# MEMORANDUM

**SUBJECT:** Public hearing and consideration of a Landmark Alteration Certificate to construct a 300 sq. ft. addition and 150 sq. ft. screened-in mechanical area and restore the trackside arched openings at the Union Pacific Depot at 30<sup>th</sup> and Pearl St., and individual landmark, per section 9-11-18 of the Boulder Revised Code (HIS2014-00299).

BOULDER HISTORIC DEPOT  
10-10-14

Figure 11. Proposed Site Plan, 2014.

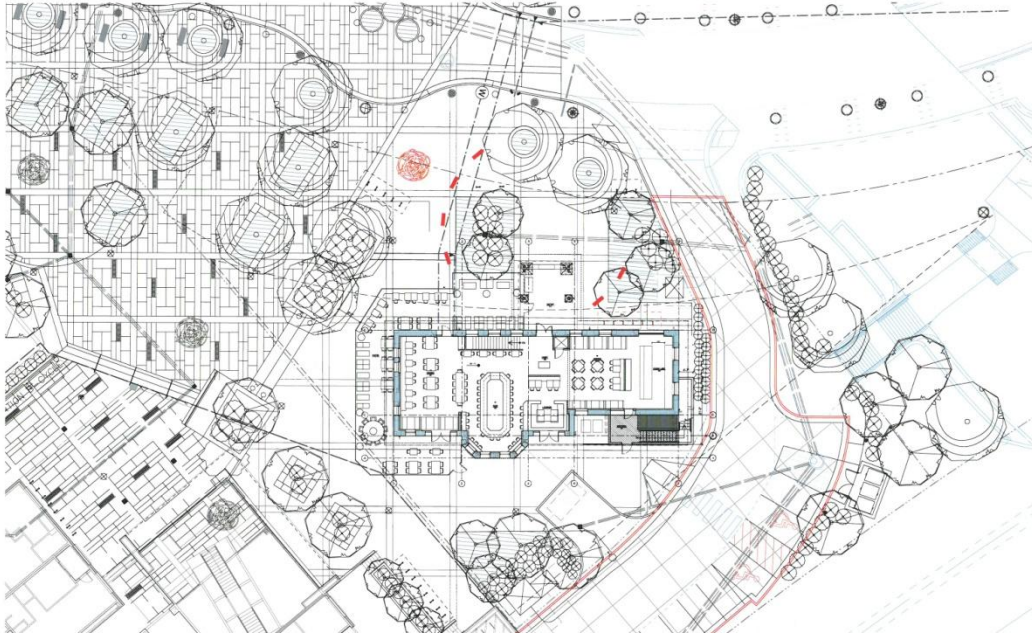
In order facilitate re-use of the depot as a restaurant, the applicant proposes an enclosed service entry of 300 square feet and a screened mechanical area of an additional 150 square feet to be constructed on the northeast corner of the building. A previous Landmark Alteration Certificate for the depot approved the installation of an exterior staircase to the basement at the north side of the building. However, the applicant indicates this configuration will not work for the proposed restaurant circulation and that the area needs to be enclosed in order to meet health code and to be usable during the winter months. The proposed restaurant also requires a mechanical service area. The applicant proposes to enclose this area with a screen in order to prevent visual exposure that would detract from the character of the building.

Figure 12. Proposed East Elevation and Perspective Sketch, 2014.

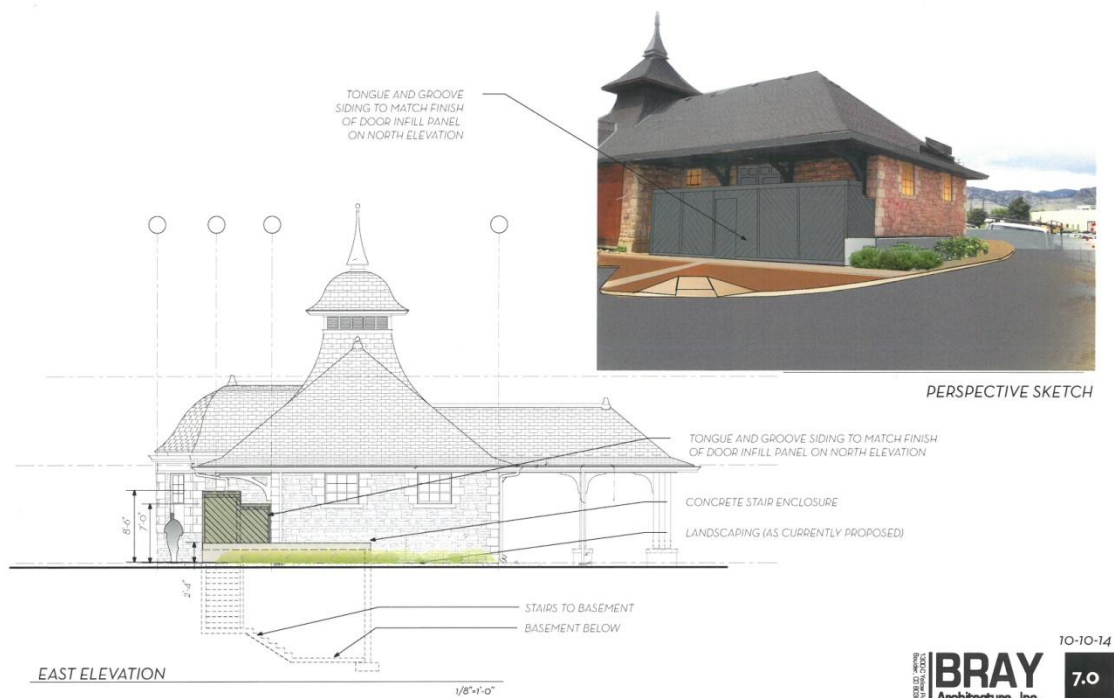
Staff finds that the construction of the proposed addition will be generally compatible and consistent with the *General Design Guidelines* (see Design Guidelines Analysis section). Historically, this end of the trackside face of the building was a service entrance and the main entrance to the freight area of the building. Repurposing the building as a restaurant requires a service entrance and a location for mechanical equipment. Given the historic of the building and steps that have been taken to ensure reversibility of the addition, the proposed additions are appropriate.

Staff considers the proposed construction of an addition on the south and east elevation of the historic Depot to be consistent with the historic preservation ordinance and Sections 3 and 4 of the *General Design Guidelines*. The addition is shown to be tucked under the over-hanging eave and separated from the decorative brackets, a character-defining feature of the Depot. The addition is proposed to be clad in tongue and groove wood, a traditional material that is complimentary but distinct from the historic building. The addition will obscure an existing opening on the south elevation, however, this incorporation of an existing opening will prevent further modification of the building. The proposed restoration of the alcoves at the arches on the south elevation is based on the original plans and historic photographs and will celebrate the building's history as a train depot. The concrete enclosure on the east elevation is simple in detailing and material, and will not detract from the historic character of the building. Overall, the proposed addition represents a creative and modest addition that will allow the building to function in the next chapter of its history.

Figure 13. Portion of the original 1890 trackside elevation for the Depot

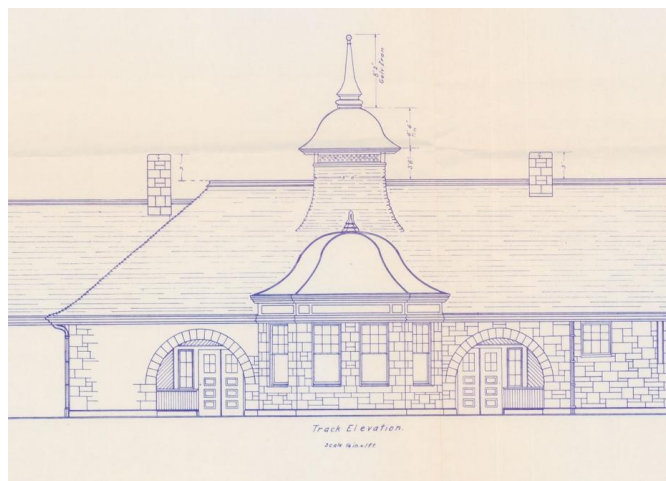
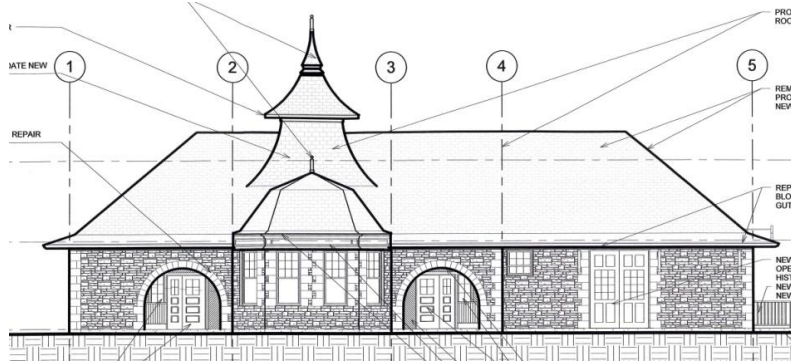
Plans also call for the rear arched trackside entrances that originally functioned as access to the segregated men's and women's "retiring rooms". Original drawings show these loggia's to be inset approximately 8 ft. from the exterior wall, and each to access the rooms via 4-panel, four light double-doors. A six light window is shown to have also been located on the inset wall in each loggia. This configuration was also shown in the 2011 submittal for the restoration of the building which was approved by the Ldrc. See Attachment D for a side-by-side view of the original and proposed treatment of the trackside arches.

Reconfiguring the, no longer extant, trackside loggias from the original design is also generally appropriate given that providing for 8' deep loggias on the back of the building is impractical and could be to the detriment of the long-term viability and condition of the depot. Staff considers that care should be taken to detail the archways and consideration might be given to inseting the arch walls at least 2' to provide more depth to better replicate this character defining feature of the building's trackside face.

2. Prior to submitting a building permit application and final issuance of the Landmark Alteration Certificate, the applicant shall submit revised drawings for review and approval by the Ldrc that show the trackside arch walls inset to a minimum depth of 2' from the exterior wall, and fenestration inside the arched openings to more closely match that shown in historic drawings.

Staff considers that in terms of the archways, details should be reviewed at the Landmarks design review committee to ensure that the fenestration inside the arches is as accurate as possible. Likewise, staff considers that effort should be made to inset the arch walls at least 2' and that this details should be reviewed and approved by the landmark design review committee.

Figure 15. Current proposal South Elevation and Perspective Sketch, 2014.

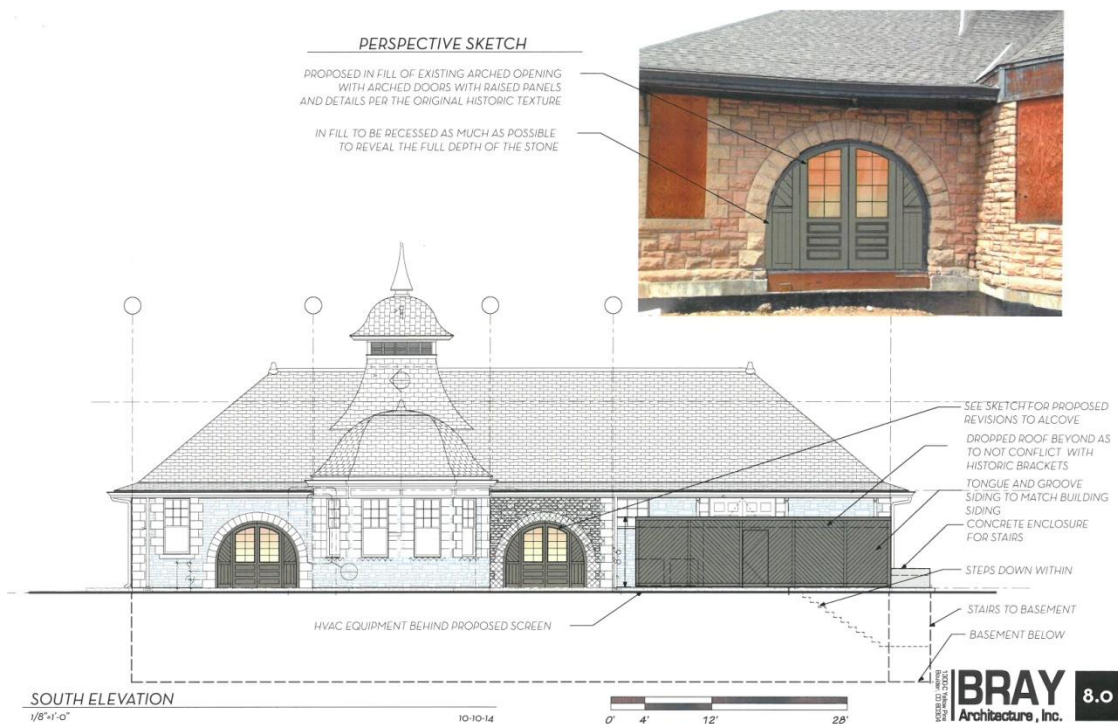
In order to provide more functional interior space for the proposed use as a restaurant, the applicant is requesting the loggia space inset approximately 1' from the exterior wall where originally the inset was approximately 8'. Likewise, the applicant is proposing the fenestrated inside each arch to be somewhat modified. Instead of the quarter light door, the request is for wider, three quarter ten light wood doors. The proposed configuration would also eliminate the six light window originally located in the loggias.

<b>3.8</b>	<b>Doors</b>		
	<i>Front doors and primary entrances are among the most important elements of historic buildings. The original size and proportion of a front door, the details of the door, the door surround, and the placement of the door all contribute to the character of the entrance.</i>		
	Guideline	Analysis	Meets Guideline?
.1	<i>Whenever possible, retain and preserve all original doors and door openings...</i>	The applicant proposes to restore the two openings on the south elevation based on the original plans and historic photographs. The historic loggias no longer exist and these features are to be reconstructed. Staff considers depth of arched openings should be increased to at least 2' to provide depth to provide for archways to read more as loggias. Proposed door design differ from those on historic drawings and windows eliminated in each arch.	Maybe
.2	<i>If replacement is found to be appropriate, the replacement door should match the original as closely as possible...</i>	The original doors no long exist. Proposed door design differ from those on historic drawings and windows eliminated in each arch.	Maybe
